## Product Alert 190502

**Subject:** Potential disengagement of Gear Box Drive Adapter from Plug Valve Plug

**To:** Customers who have 3" and 4" Gear Operated Plug Valves with Gear Operators built between October 1<sup>st</sup>, 2018 and April 20<sup>th</sup>, 2019.

## DISASSEMBLY & REASSEMBLY OF GEAR OPERATED 3" & 4" LOW TORQUE PLUG VALVE ASSEMBLIES WITH 'GROP-DT36-BUSHING'

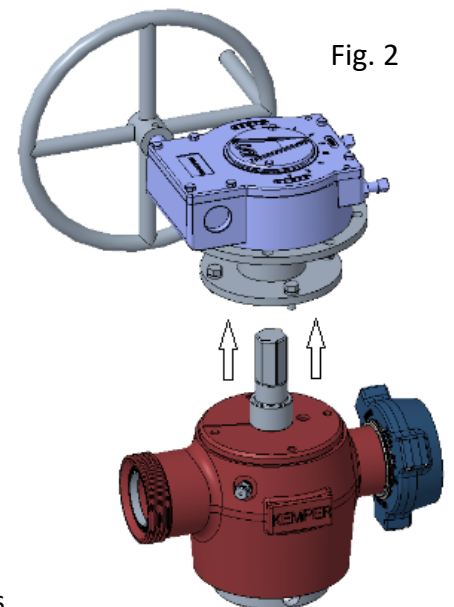
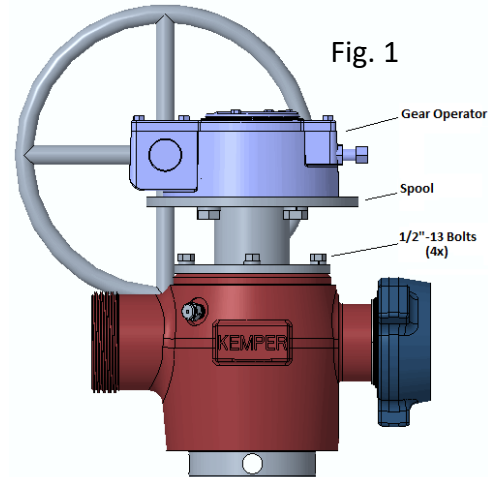
1. Secure Gear Operated Plug Valve Assembly to suitable work station in the vertical position
  - Note Serial # of valve assembly and handwheel position
2. Open valve completely by rotating hand wheel counter-clockwise until wheel stop is contacted.
  - Visually verify that valve is open by looking through flow bore
3. Remove the four 1/2"-13 grade 8 bolts that attach Spool to Plug Valve Body (Fig. 1)
  - Do not remove bolts that attach gear operator to spool
  - Note orientation of handwheel to nut/female end for reassembly
4. With assistance lift Gear Op and Spool vertically 12" to disengage from Gear Box Drive Adapter (Fig. 2)
  - Set aside on clean surface

1. Ensure Gear Box Drive Adapter is installed onto the Plug Hex End (Fig. 3)
  - 3" Valve shown, 4" slightly different
2. Install (by hand) GRO-P-DT36-BUSHING over hex end of Gear Box Drive Adapter (Fig. 4)

- Bushing will be loose fitting, must bottom out on adapter as shown
3. Maintaining the same orientation as disassembly, re-install Gear Operator and Spool by lowering vertically onto Gear Box Drive Adapter (Fig. 5)
